Our Ref: FLP1203/22
WYP10736/18

RE: CREEKSTONE STAGE N6- FUNCTIONAL LAYOUT PLAN APPROVAL

CREEKSTONE ESTATE STAGE N6
FUNCTIONAL LAYOUT PLAN

- Drawing No. 8584E/N6FL sheet 01 of 02 Revision P1
- Drawing No. 8584E/N6FL sheet 02 of 02 Revision P1

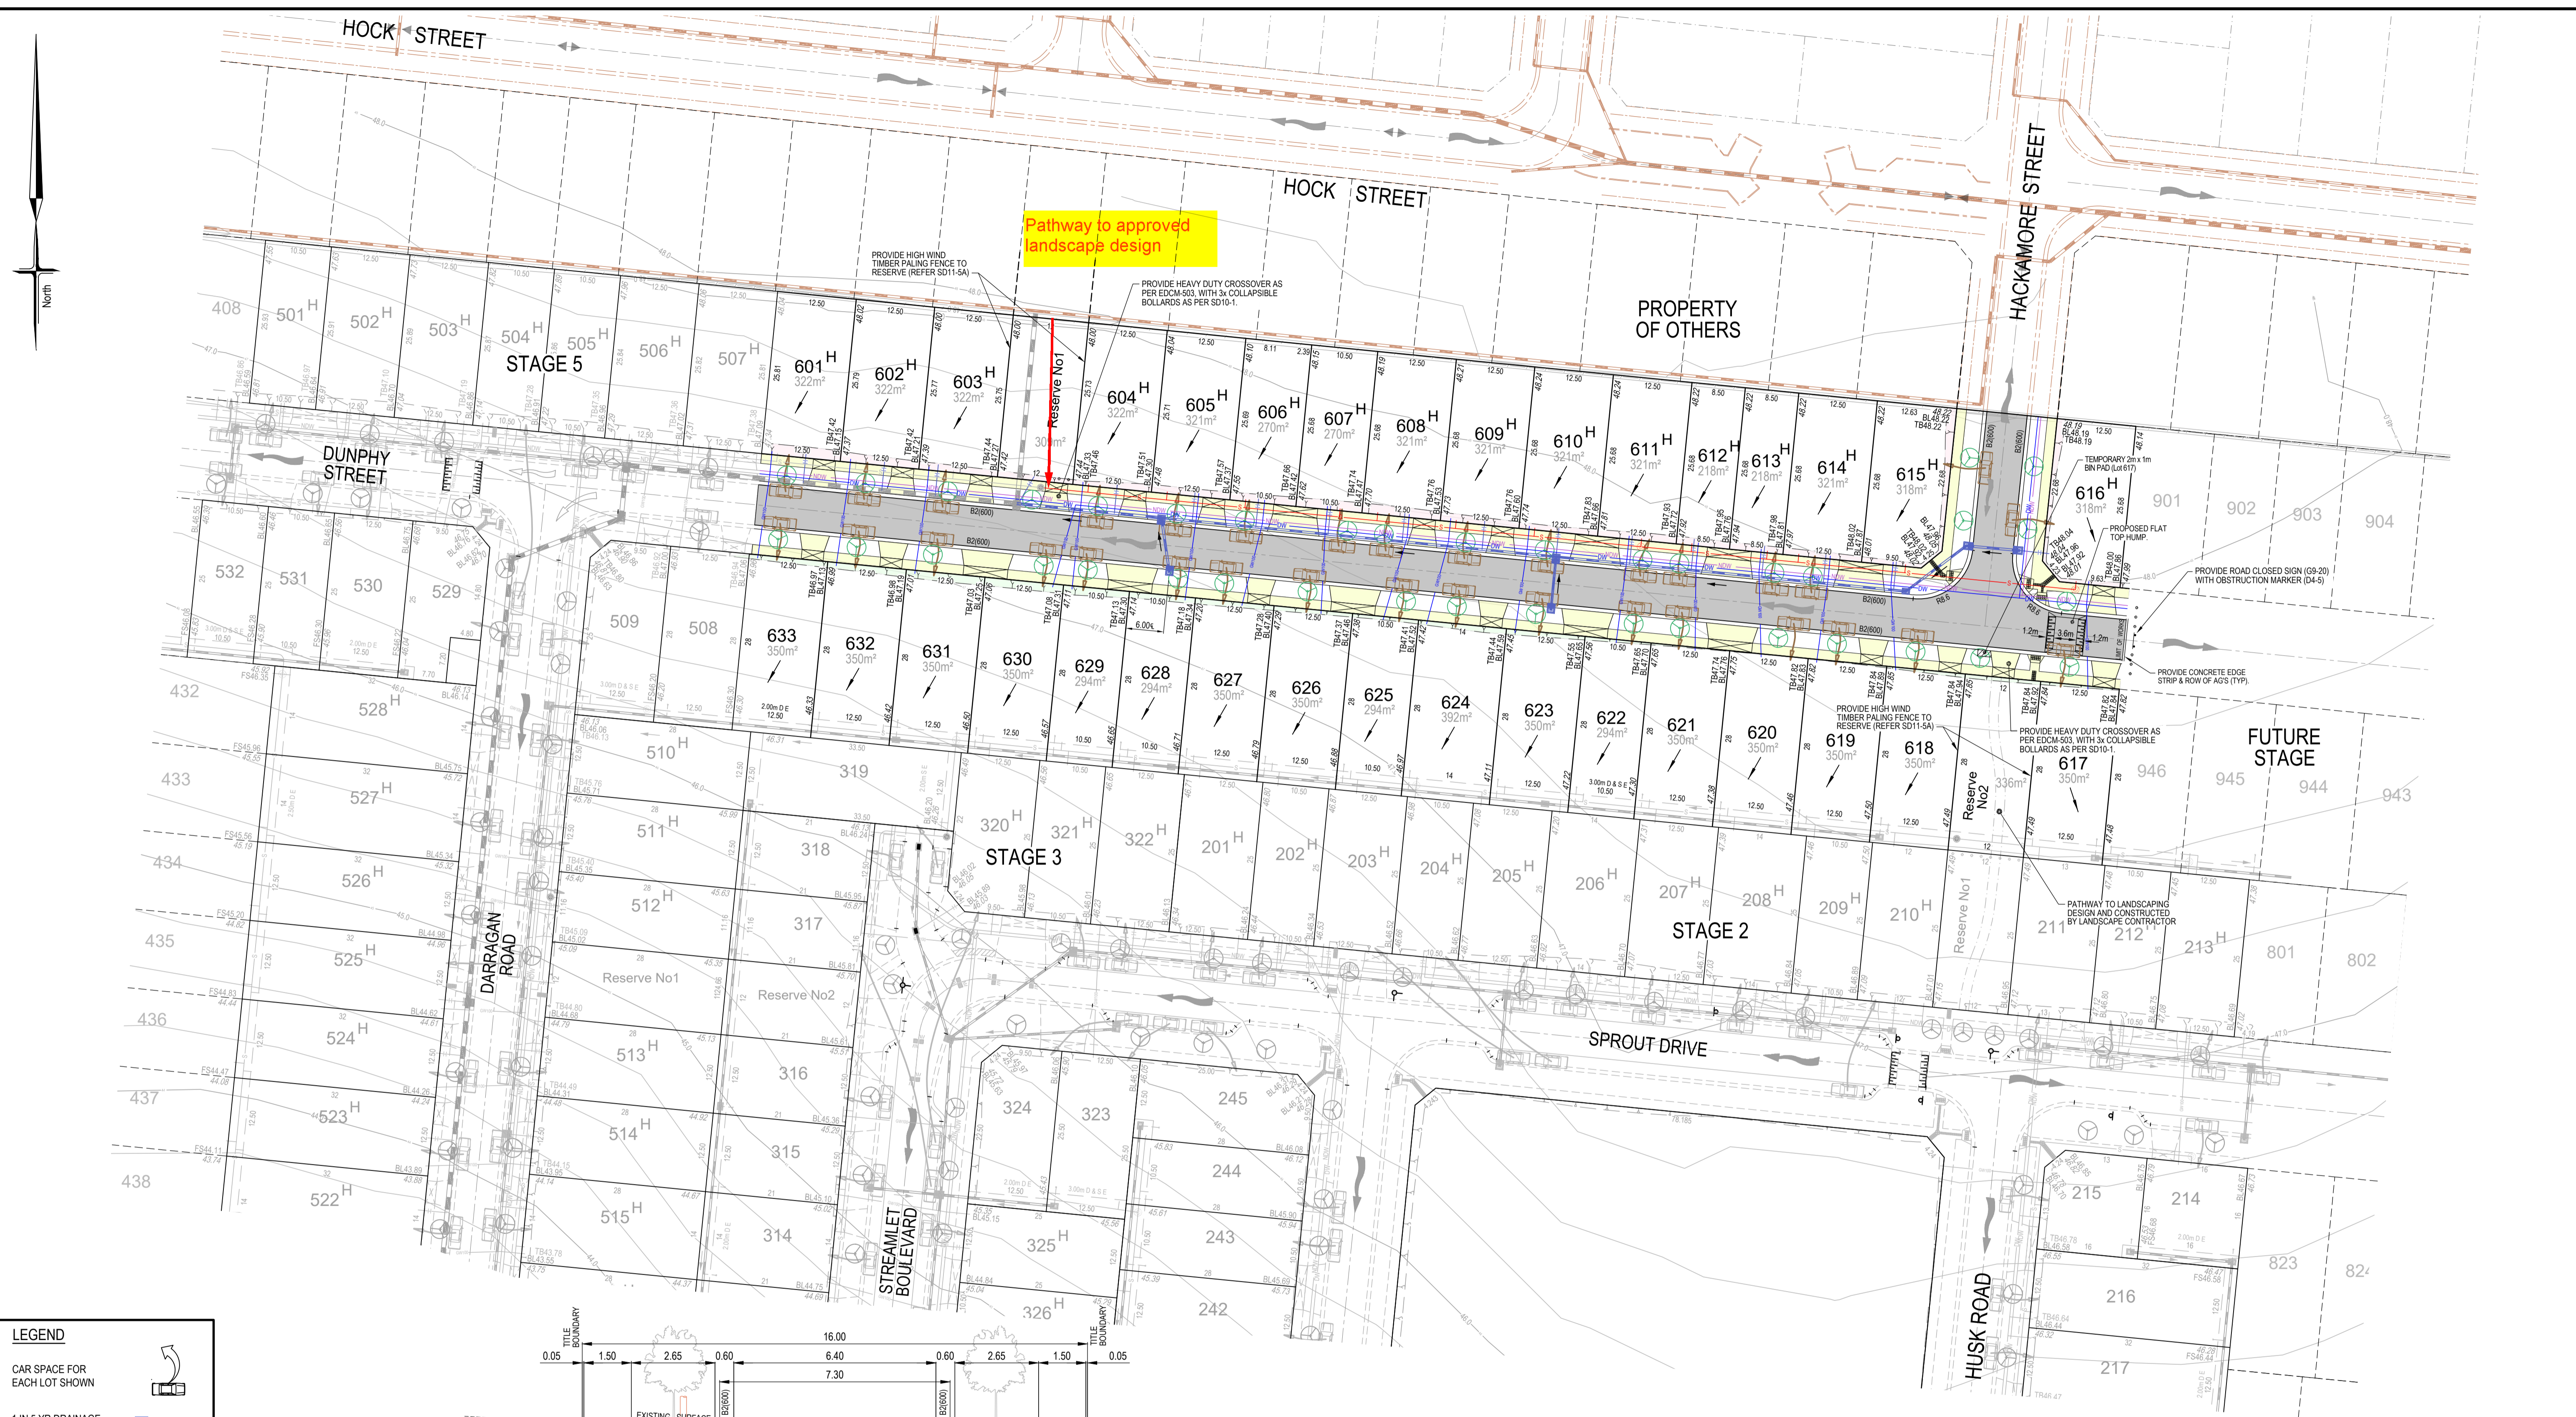
Please be advised that the functional layout plans submitted to Council for Creekstone Stage N6 are approved, subject to the following conditions:-

1. Tree locations and number of trees shown are indicative only and will be finalised as part of the landscape plan approval process.
2. This approval is limited to road and drainage works only, and does not extend to works associated with open space.
3. Wyndham City Specifications and standard details shall be read in conjunction with the approved plans. No work is to start on this stage until Detailed Engineering Drawings have been approved, and the Plan of Subdivision has been certified by Council.
4. The approved Functional Layout Plans may need to be amended during the detailed engineering approval process.
